City of Detroit

RE: Request of SDG Associates, LLC on behalf of the Detroit Regional Convention Facility Authority for PC/PCA (Public Center/Public Center Adjacent) Special District Review of proposed signs and sculpture at the Huntington Place at 1 Washington Boulevard (formerly TCF Center). (**RECOMMEND APPROVAL**)

DATE: April 19, 2022

*Proposed sign to be located above entrance facing Washington Boulevard (east)
Three signs are proposed, one above each entrance*

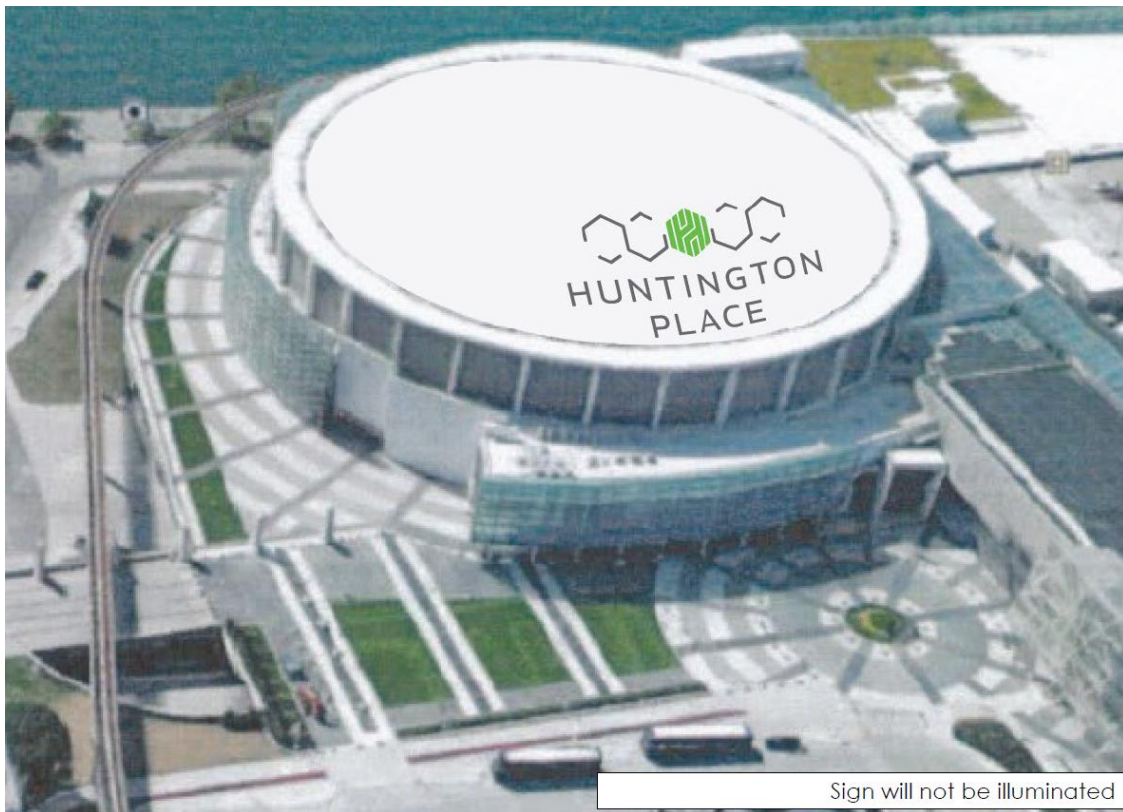
Generally, staff is fine with the proposed new signage, but for a minor concern with the wall mounted signs above the entry points. We are fine with the method by which they are to be affixed to the exterior wall and the appearance as described. However, the depiction of the signs in the included materials is a bit inconsistent with that description. The signs are to be carried on a gray aluminum backing panel that will obscure view of the connecting hardware and power supply. This panel will also cover the underlying wall surface and pattern as well as project from the wall. The depictions provided show the signage fixtures applied directly to the wall preserving more of the existing appearance than will be the case. The final set of drawing to be presented to Council for approval should include more accurate depictions of this signage as it will be installed. With this understanding and based upon the above analysis, the City Planning Commission staff recommends approval of the proposed signs and sculpture.
